REMARKS

Fig.3

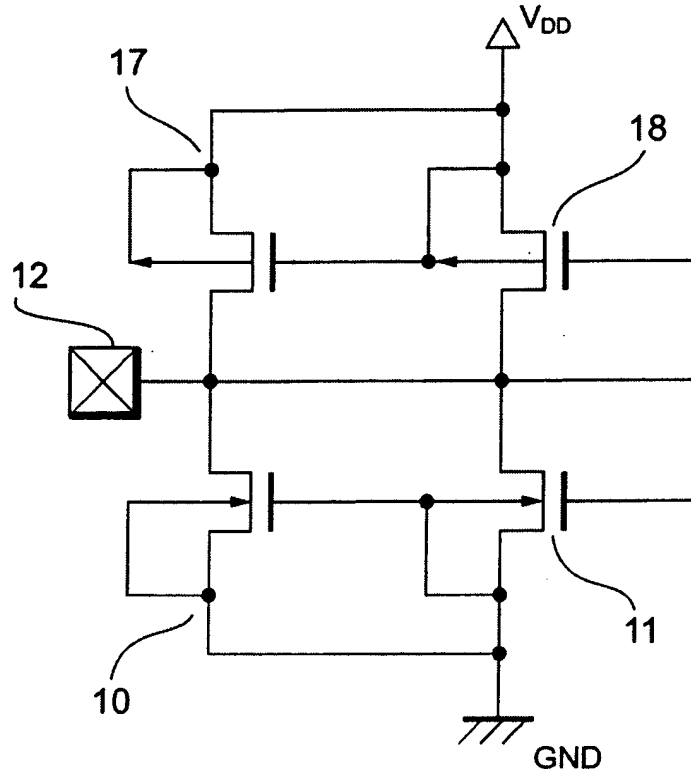
The objection is respectfully traversed on the basis that Fig. 3 already illustrates what is asserted to be lacking. In Fig. 3, the first conductivity type transistors are the transistors 10 and 11, which also appear in Fig. 1(a), is given as first conductivity type at page 9, line 25; that transistors 10 and 11 are both of this type is shown by the orientation of their arrows, which both point in to indicate the P-well 22 (see Fig. 1(b)). Conversely, transistors 17 and 18, with their arrows pointing out, are automatically of the second conductivity type and therefore include N-wells corresponding to the P-wells illustrated in Figs. 1(a) (by arrows) and Fig. 1(b) (by numeral 22). Transistor 17 is the analogue of protection transistor 10, and therefore it is the protection resistor of the second conductivity type.

(1) As to the *second-conductivity-type MOS protection transistor having a drain connected to the drain of said second-conductivity-type MOS output transistor*, the Examiner is invited to consider the attached photocopy of Fig. 3 where this connection is indicated by the lower yellow highlighted path.

(2) As to a *source connected to a source of said second-conductivity-type MOS output transistor*, the source of transistor 17 is connected to the source of transistor 18 through the upper highlighted path in Fig. 3.

(3) As to a *gate connected to a first-conductivity-type layer under a gate of said second-conductivity-type MOS output transistor*, the Examiner is invited to consider the middle highlighted path on the attached photocopy of Fig. 3 and the specification at page 11, line 10, ✓

which reads: “In this case, as shown in FIG. 3, on a PMOS output transistor 18 side, the gate [heavy vertical line] of a PMOS protection transistor 17 and a N-well of the PMOS output transistor [arrow leading out from PMOS transistor 18] are connected.”
